**Economic Commission for Europe****Inland Transport Committee****World Forum for Harmonization of Vehicle Regulations****Working Party on Noise****Fifty-seventh session**

**Regulation No. 117 (Tyre rolling noise and wet grip adhesion)****Proposal for 03 series of amendments to Regulation No. 117****Submitted by the Chair and Vice-chair of the Working Party on Noise<sup>1</sup>**

The text reproduced below was proposed by the Chair and Vice-Chair of GRB to allow the use of the test track complying with ISO 10844:2011 in a new series of amendments to the UN Regulation. The proposal is based on a document without symbol (GRB-56-20) distributed at the fifty-sixth session of the Working Party on Noise (GRB)(ECE/TRANS/WP.29/GRB/54, para. 19). The modification to the existing text of the UN Regulation, are marked in bold for new or strikethrough for deleted characters.

~~Figure 2~~

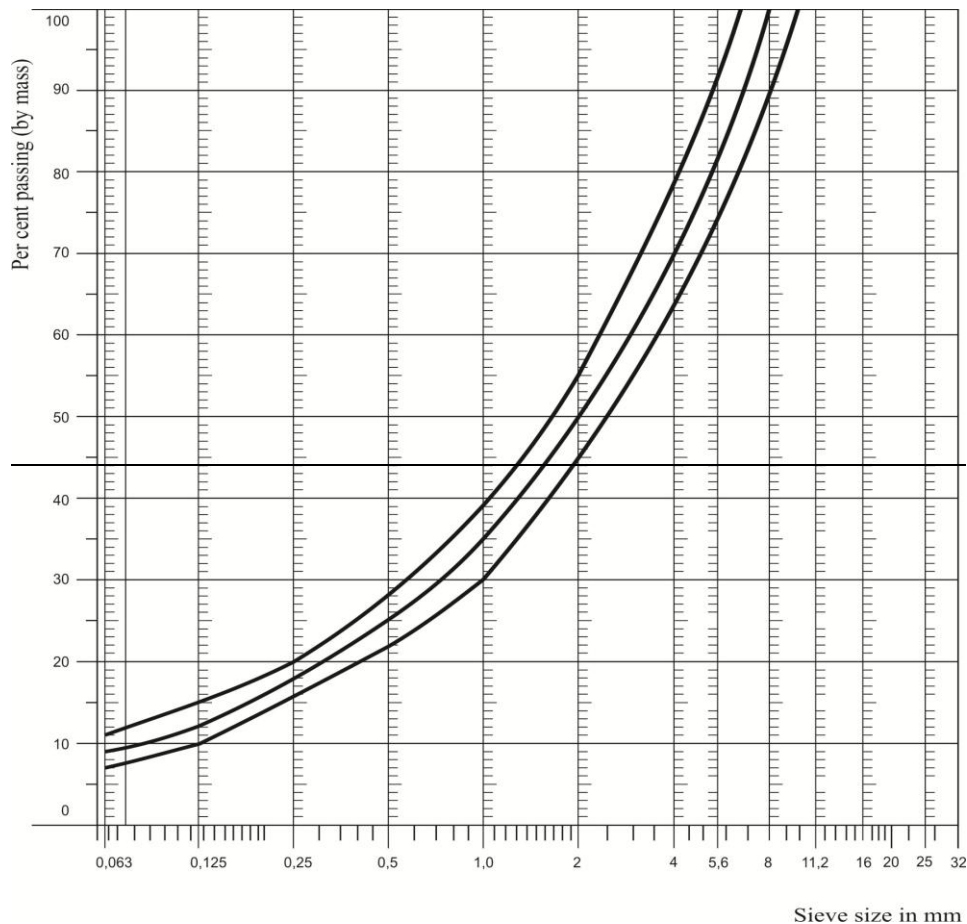
~~As a guide to the surface constructor, an aggregate grading curve which will give desired characteristics is shown in Figure 2. In addition, Table 1 gives some guidelines in order to obtain the desired texture and durability. The grading curve fits the following formula:~~

~~$d_{\max}$  = 8 mm for the mean curve~~

~~= 10 mm for the lower tolerance curve~~

~~= 6.3 mm for the upper tolerance curve~~

Figure 1  
Size of the test track

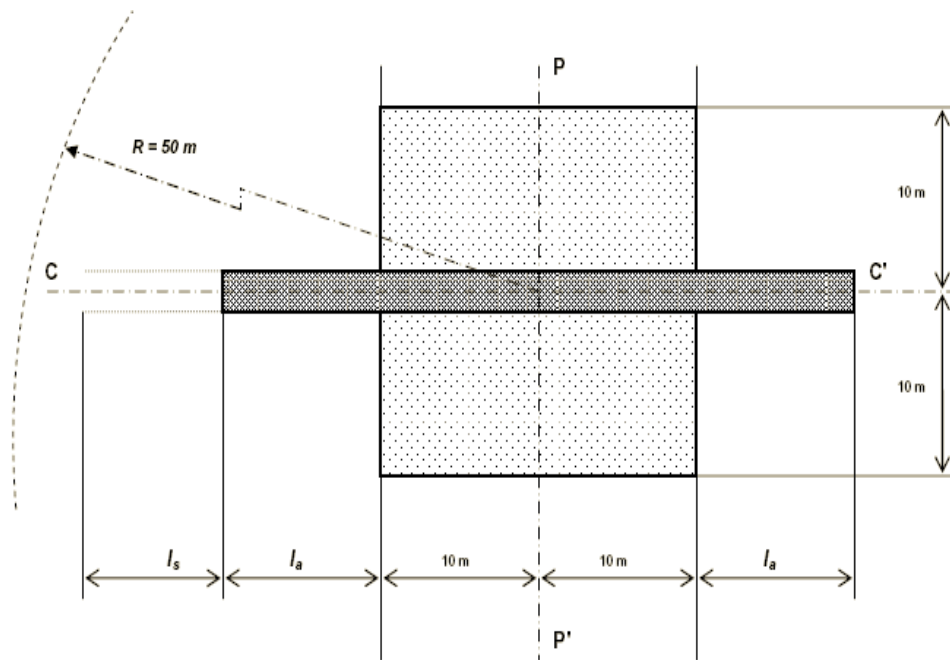
The test track shall consist of two areas, a drive lane and a propagation area. The dimensions shall comply with Figure 1 and Table 1.

A drive lane with a length of  $l_a$  and width of at least 3.0 m that is centered around line PP'. The value of  $l_a$  is defined in Table 1.

The propagation area shall extend at least 10 m from the centre of the drive lane and at least 10 m at both sides of the line PP'.

Figure 2  
Propagation area slope in transverse direction

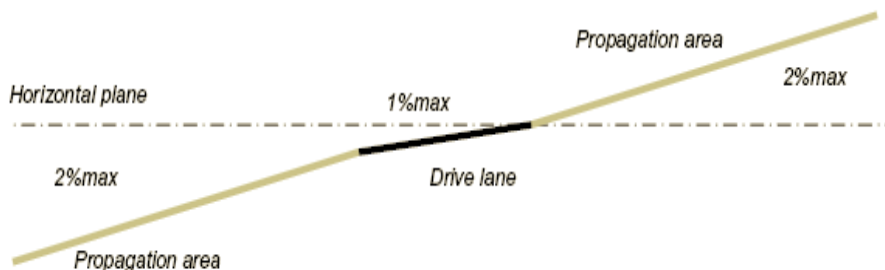
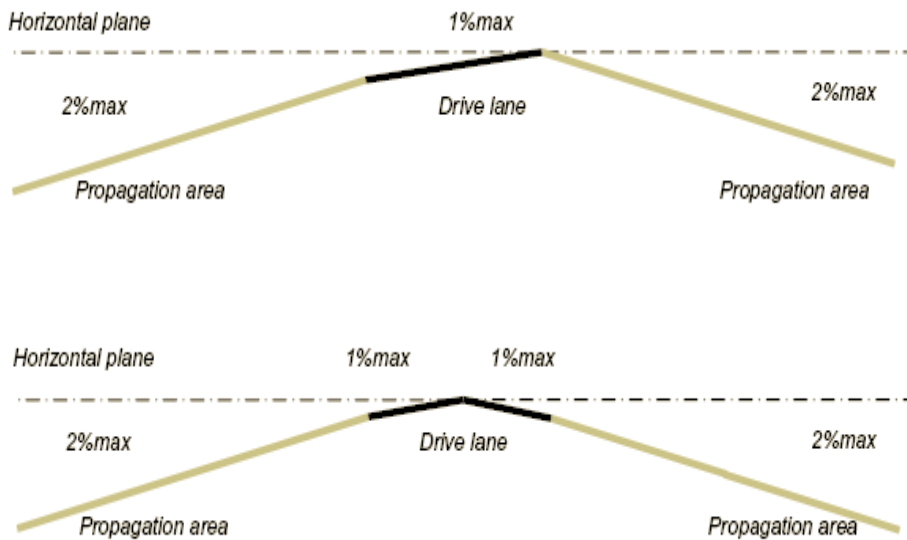
- (i) For acceptance of the test track only, transverse irregularities equal to or less than 0.003 m and longitudinal irregularities equal to or less than 0.002 m measured with the straightedge according to EN 13036-7;
- (ii) For periodical checking of the test track only, transverse irregularities equal to or less than 0.005 m and longitudinal irregularities equal to or less than 0.005 m measured with the straightedge according to EN 13036-7;
- (iii) For acceptance only, deviation from the horizontal plane in transverse direction of 1.0 per cent maximum (see Figure 2) and in a longitudinal direction of 0.5 per cent maximum.

- (i) The propagation area shall have irregularities equal to or less than 0.02 m measured with the straightedge according to EN 13036-7;
- (ii) The propagation area may have one or both sides lower than the drive lane. Cross fall in transverse direction, measured using an appropriate instrument, shall be equal or less than 2.0 per cent (see Figure 2);

**1 per cent max: allowed drive lane cross fall**

**2 per cent max: allowed propagation area cross fall**

**Propagation area – Steps or discontinuities**

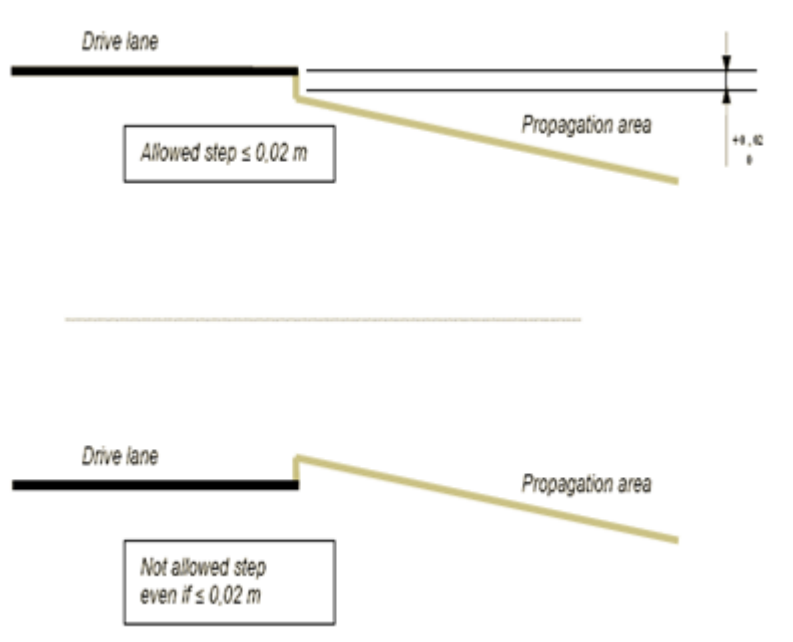
Steps or discontinuities between the propagation area and the drive lane shall be between 0 and +0.02 m. Negative steps are not allowed (see Figure 3).

**Figure 4**  
Sieving curve area

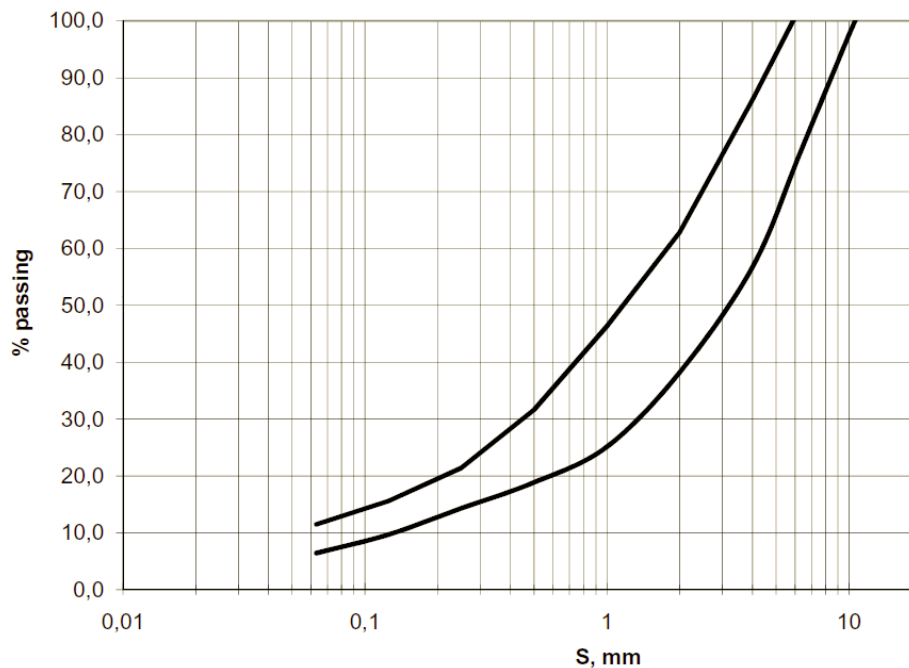
- (a) be of dense asphalt concrete;
- (b) exhibit a sound absorption equal to or less than 8 per cent in any one-third-octave band between 315 Hz and 1 600 Hz when measured according to 4.3;
- (c) have a maximum chipping size of 8 mm (tolerance allowed between 6.3 mm to 10 mm);
- (d) have a thickness of the wearing course greater than or equal to 30 mm;
- (e) have a Mean Profile Depth measured according to ISO 13473-1 of  $0.5 \text{ mm} \pm 0.2 \text{ mm}$ ;
- (f) have a target sieving curve for the aggregate as shown in Figure 4.
